Product Change Notification

Change Notification #: 113293 - 00
Change Title: Intel® Server System R1304GZ4GS9
PCN 113293-00, Product Design
Update the System Rear Panel, add a Mylar
and a Plastic Block
Date of Publication: October 13, 2014

Figure One

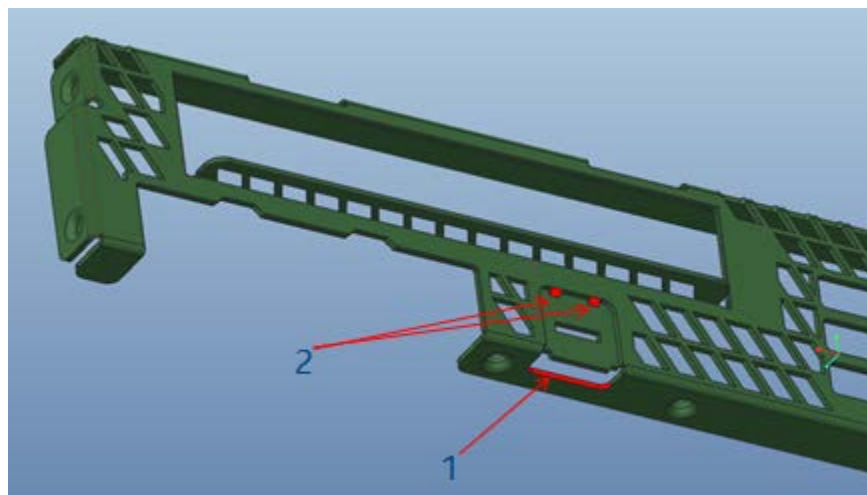
1. Add a connection at the bottom of the RMM4 (Remote Management Module 4) slot to improve structure strength. See item 1 in the Figure One.
2. Update the one big center joint to two smaller joints so that the joints will not conflict with the LAN cable connector latch. See item 2 in the Figure One.

Figure Three

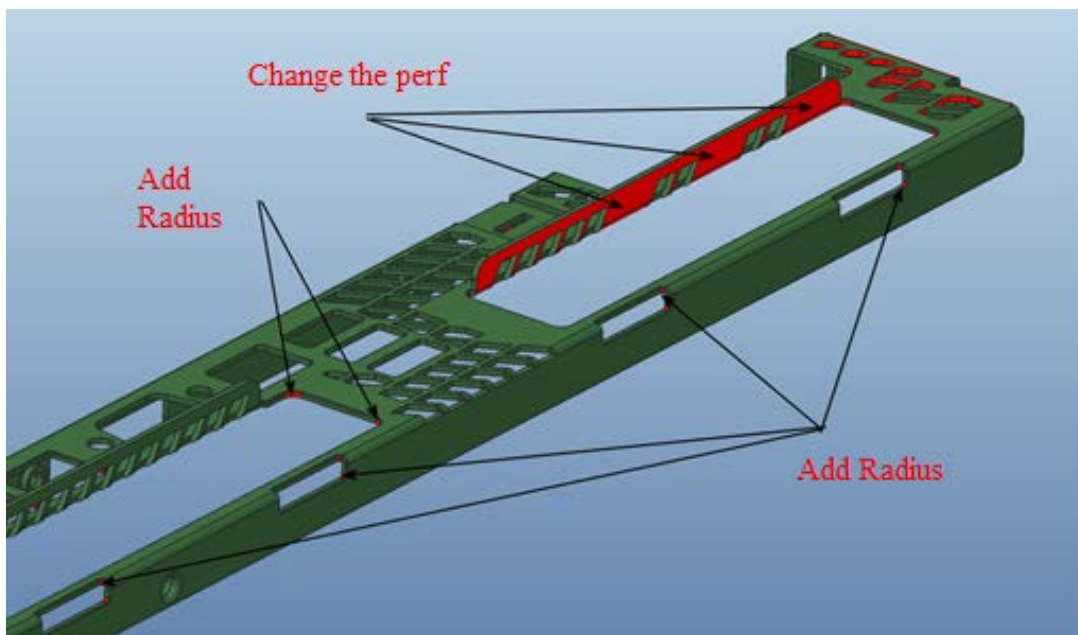
4. Update the perf and add radius to improve structure strength. See the Figure Three and Four.

Figure Five

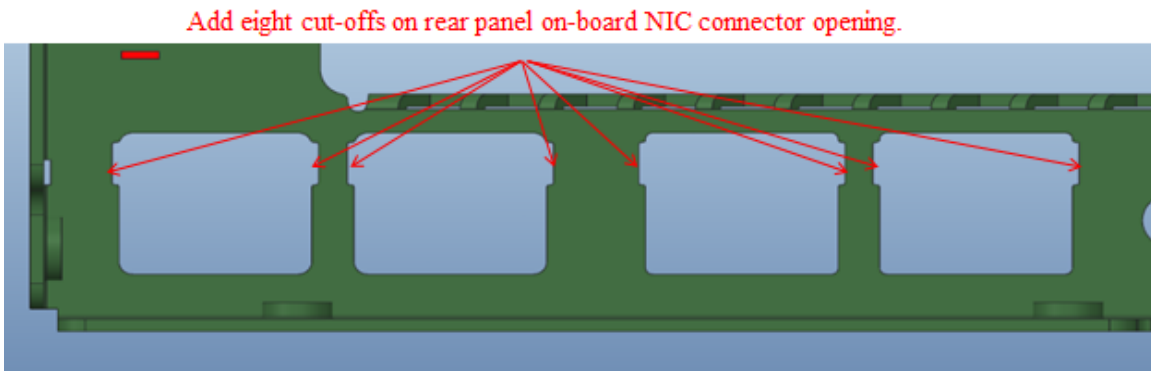
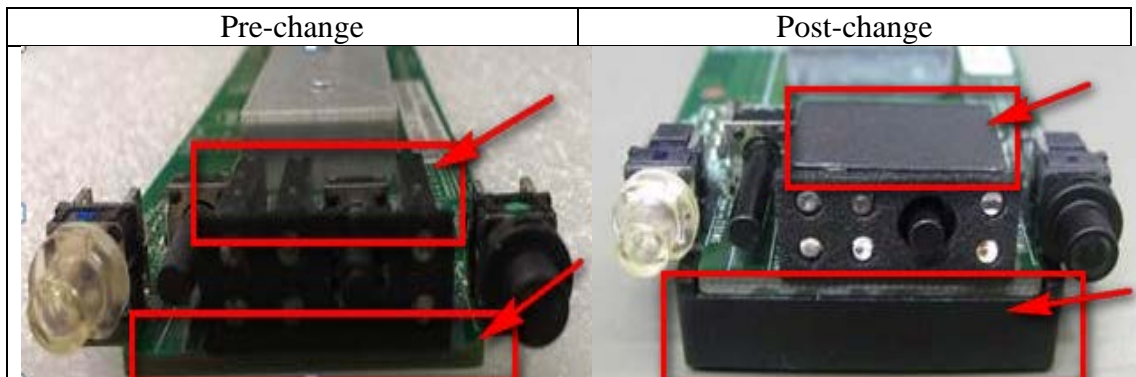
5. Add eight cut-offs around the on-board NIC (Network Interface Controller) openings to improve the LED visibility. See the Figure Five.
